PLANNING BOARD MEETING AGENDA

January 24, 2024 at 7:30 PM

- 1. CONTINUED PUBLIC HEARING ON THE APPLICATION SUBMITTED BY YITZCHOK WIEDER FOR A WETLANDS PERMIT.** Affecting property located on the west side of Tranquility Road, 575 feet south of Joy Road. Designated on the Town of Ramapo Tax Map as Parcel ID#41.09-1-28. Subject property is located at 49 Tranquility Road.
- 2. CONTINUED PUBLIC HEARING ON THE APPLICATION SUBMITTED BY ROCKLAND TREE EXPERT CO., INC. DBA IRA WICKES/ARBORISTS FOR AN AMENDED SITE PLAN AND SPECIAL PERMIT.** Affecting property located on the South side of McNamara Road, 0 feet West of Union Road. Designated on the Town of Ramapo Tax Map as Parcel ID#42.13-1-22. Subject property is located at 11 McNamara Road.

Re: 49 Tranquility Road
Addition Plan & Wetland Permit Application
Section 49.01-1-28

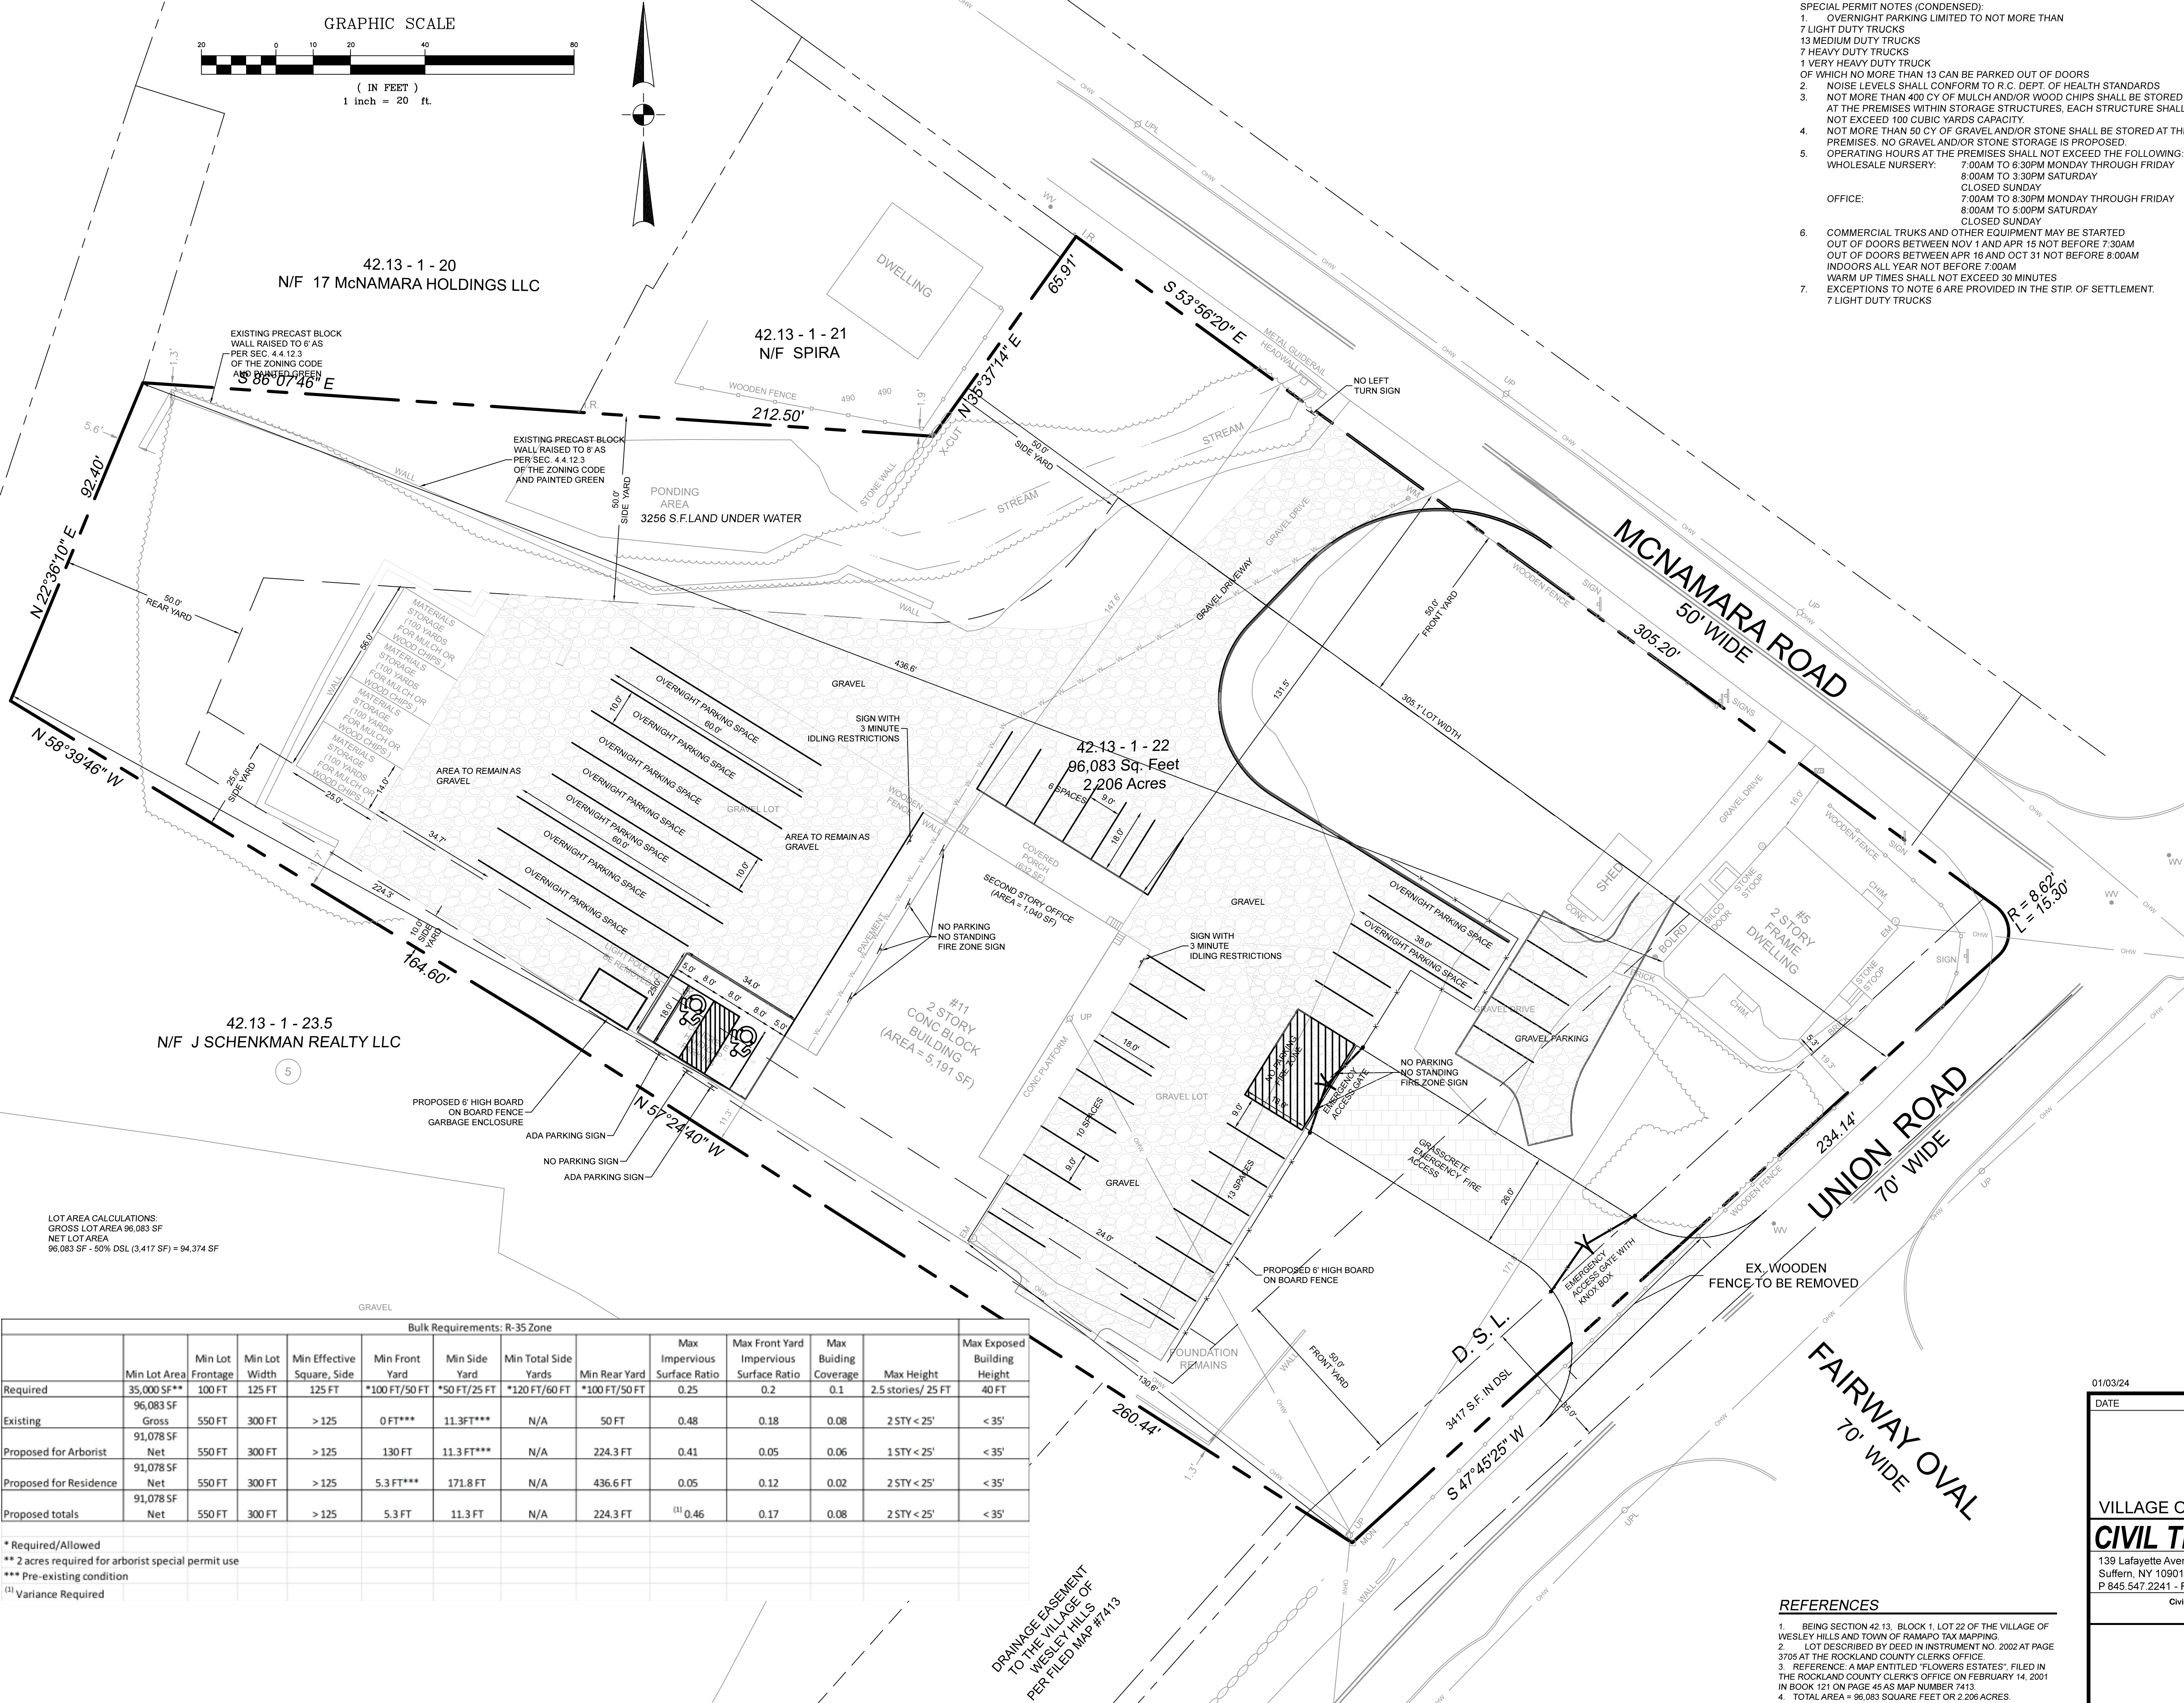
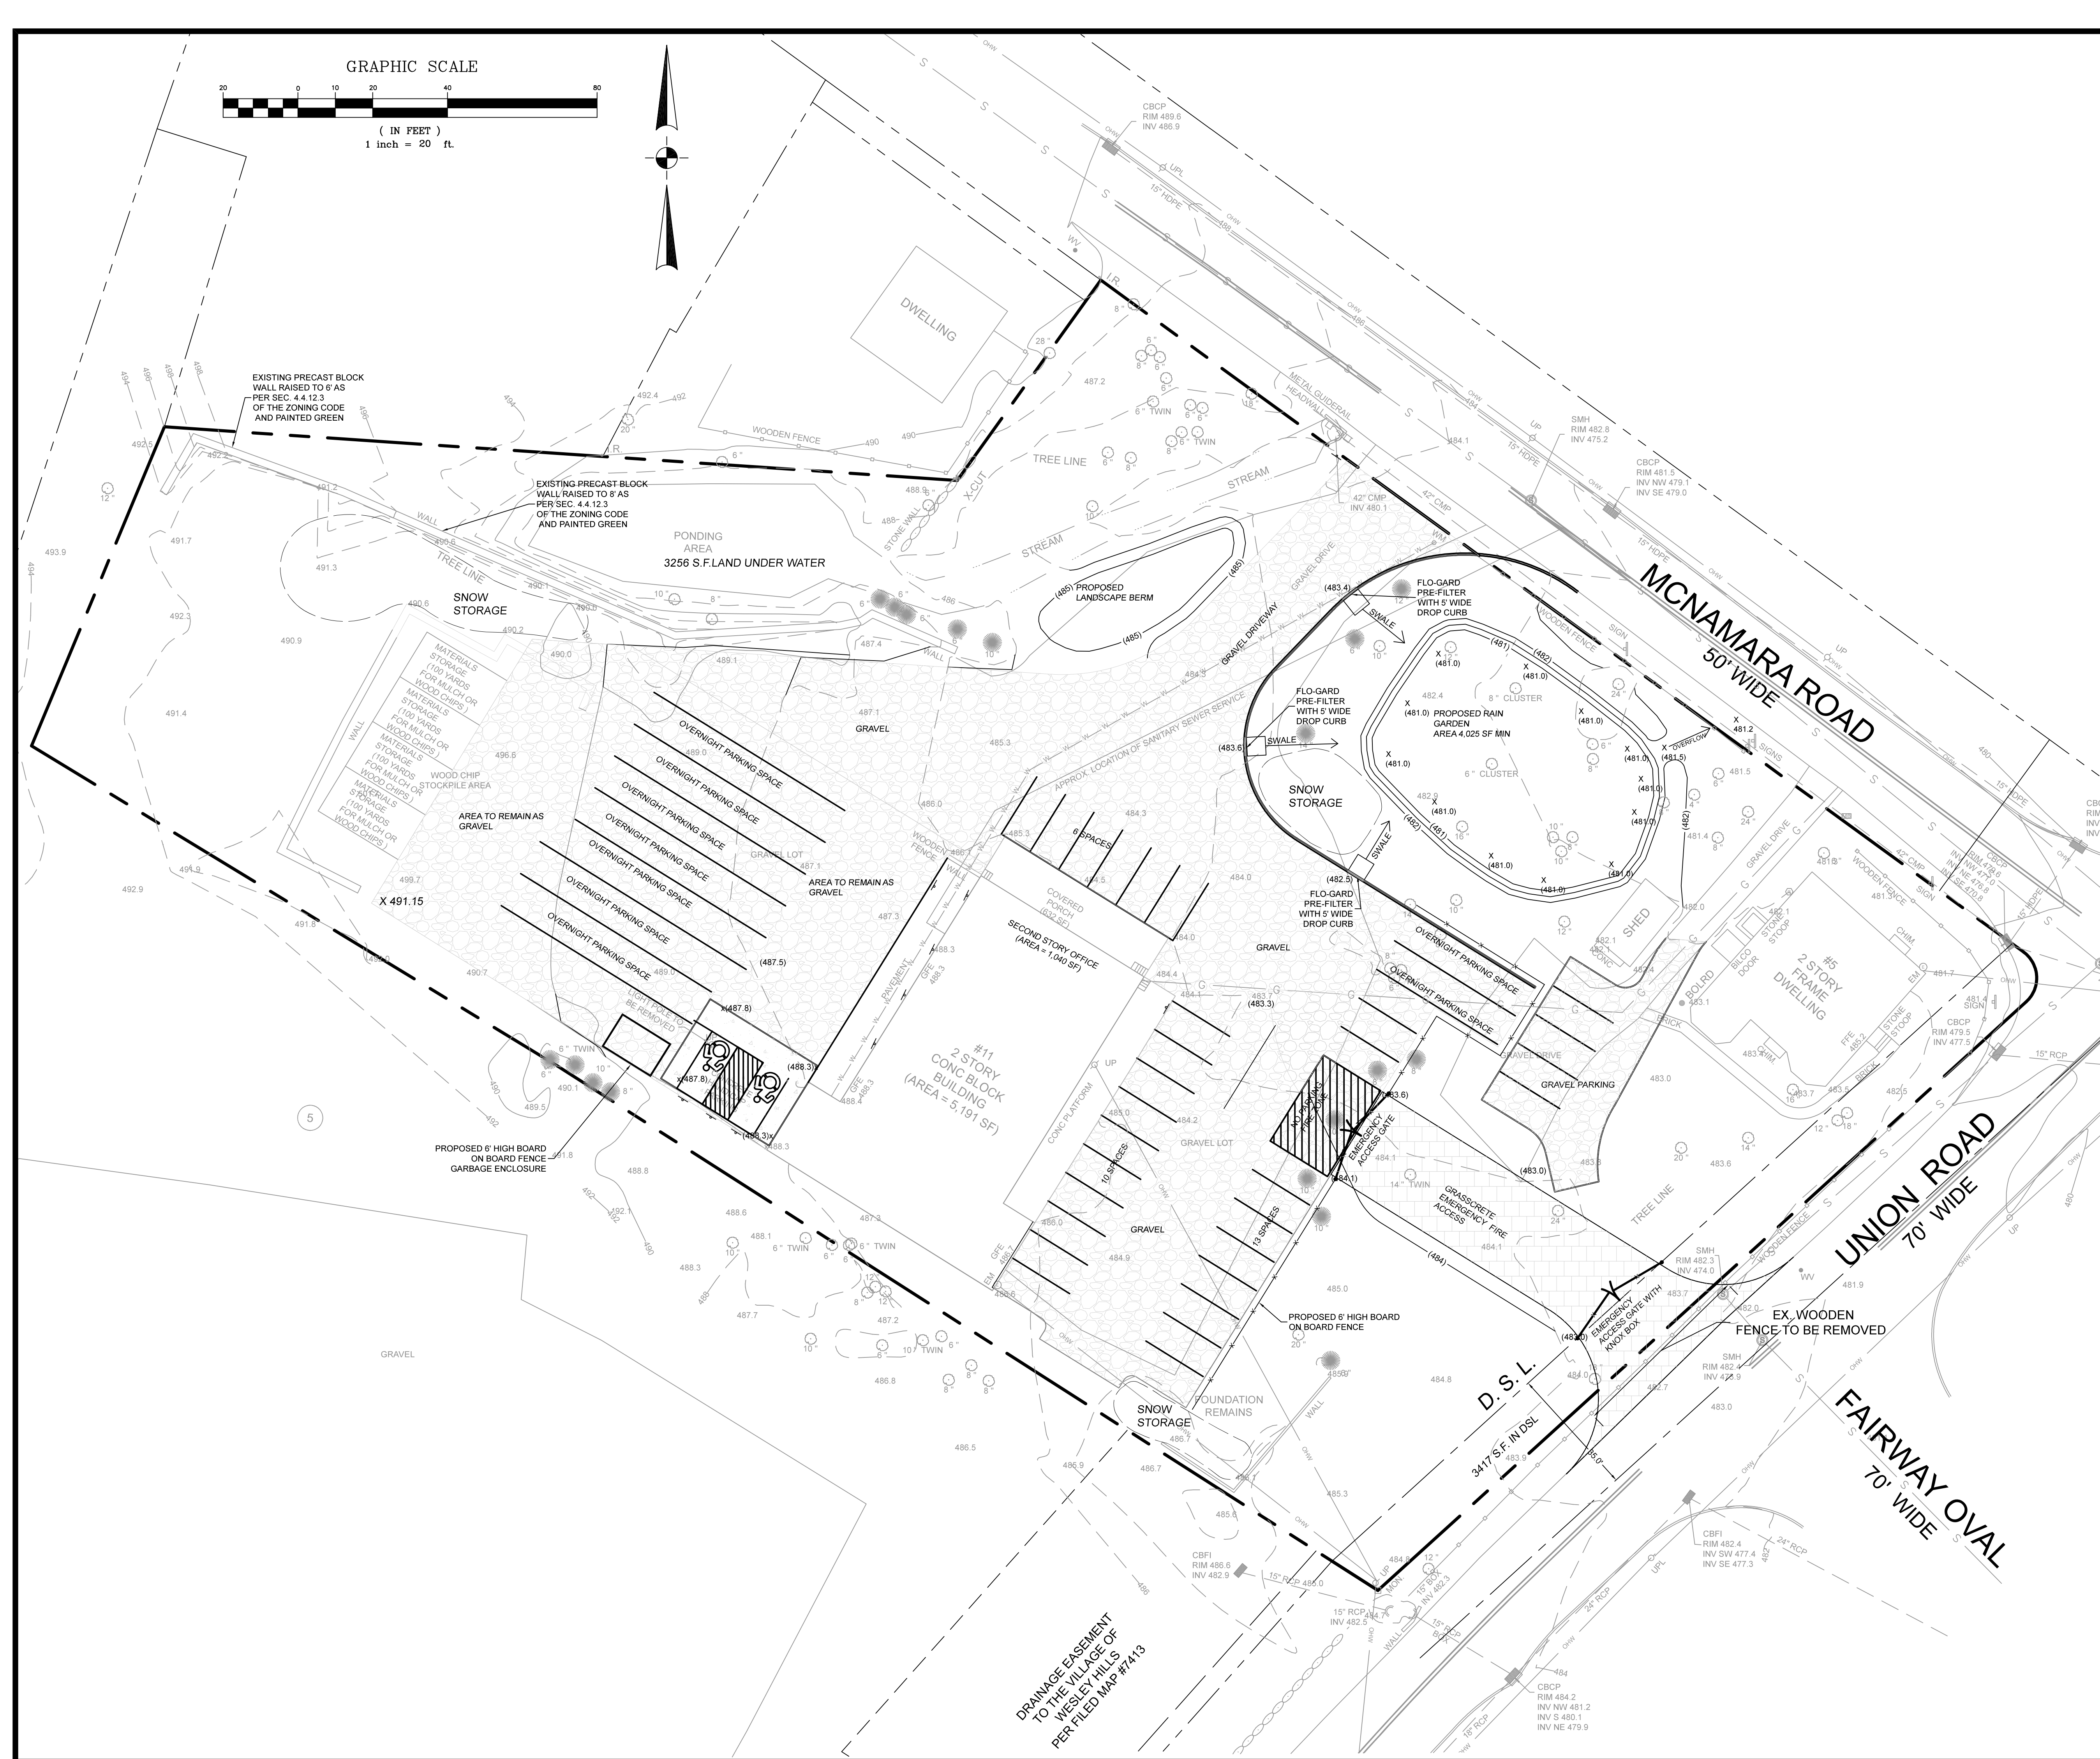
3. We appreciate the gravel removal west of the main driveway and restoration of the stream bank with the installation of the “proposed landscape berm.” Please provide details of the height and plant materials proposed for this berm feature as part of the landscape plan (which were not included on sheet 3).

4. We note that on sheet 3 a rain garden is proposed east of the main driveway. We note that on existing conditions sheet 4, about a dozen large trees (including one 24” and one 16”) are located within this rain garden area but are not shown as “to be removed.” Typically when a rain garden is constructed, and underdrain system must be installed, which would require the clearing of all existing vegetation. Please clarify what will happen to the large existing trees if a rain garden is installed in this area indicated.

3. We appreciate the gravel removal west of the main driveway and restoration of the stream bank with the installation of the "proposed landscape berm." Please provide details of the height and plant materials proposed for this berm feature as part of the landscape plan (which were not included on sheet 3).

4. We note that on sheet 3 a rain garden is proposed east of the main driveway. We note that on existing conditions sheet 4, about a dozen large trees (including one 24" and one 16") are located within this rain garden area but are not shown as "to be removed." Typically when a rain garden is constructed, and underdrain system must be installed, which would require the clearing of all existing vegetation. Please clarify what will happen to the large existing trees if a rain garden is installed in this area indicated.

3. Regarding comment 3 of our previous memorandum, we appreciate the gravel removal west of the main driveway and restoration of the stream bank with the installation of the "proposed landscape berm." As requested, the height and plant materials proposed for this berm feature are now indicated on the landscaping plan (sheet 4), and our comment has been resolved.
